# Access Compliance Report

## Public Rights-of-Way

Intersection ID: 12869	Main Street: E_TRADE_ST	Cross Street: N_ALEXANDER_ST	Location: S
ADA ID: 2F28DBC5664F	Ramp Type: PerpDiag	Initial Pass/Fail: Fail	Overall Compliance: No
Severity Score: 12.5			
Codes/Mitigation Info/Possible Solution		Field Measurements/Component Compliance

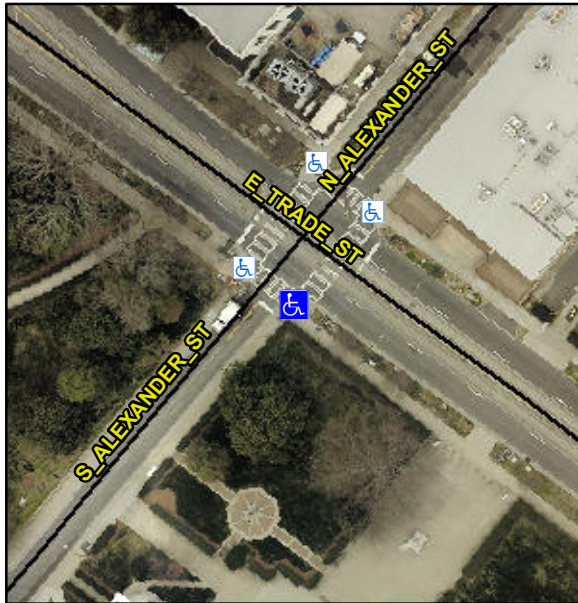
**Not Found, R304.5.3**

Compliance	Description	Data	Compliance	Description	Data
N/A	Ramp Length (in)	76.0	Yes	Ramp Slope (%)	5.5
Yes	Ramp Width (in)	48.0	No	Ramp XSlope (%)	5.4
N/A	Flare Type LT	N/A	N/A	Flare Type RT	N/A
N/A	Flare Slope LT (%)	N/A	N/A	Flare Slope RT (%)	N/A
N/A	Flare Traversable LT?	N/A	N/A	Flare Traversable RT?	N/A
N/A	Landing Length (in)	N/A	N/A	DWS Provided?	N/A
N/A	Landing Width (in)	N/A	N/A	DWS Contrast?	N/A
N/A	Landing Slope (%)	N/A	N/A	DWS Length (in)	N/A
N/A	Landing X Slope (%)	N/A	N/A	DWS Full Width?	N/A
N/A	Landing Curb? (Y/N)	N/A	N/A	DWS Offset (in)	N/A
N/A	Shared Landing?	N/A			
N/A	Gutter Ponding?	N/A	N/A	Gutter Slope (%)	N/A
N/A	Gutter Lip Ht (in)	N/A	N/A	Gutter X Slope (%)	N/A
N/A	Painted X Walk1?	Yes	N/A	Painted X Walk2?	Yes
	X Walk 1 Direction	To NE		X Walk 2 Direction	To NW
N/A	X Walk 1 Width (in)	111.0	N/A	X Walk 2 Width (in)	109.0
	X Walk 1 Slope (%)	3.4		X Walk 2 Slope (%)	4.0
	X Walk 1 X Slope (%)	4.2		X Walk 2 X Slope (%)	0.9

**Remove & Replace Curb Ramp With Two New Directional Ramps or Equivalent.**
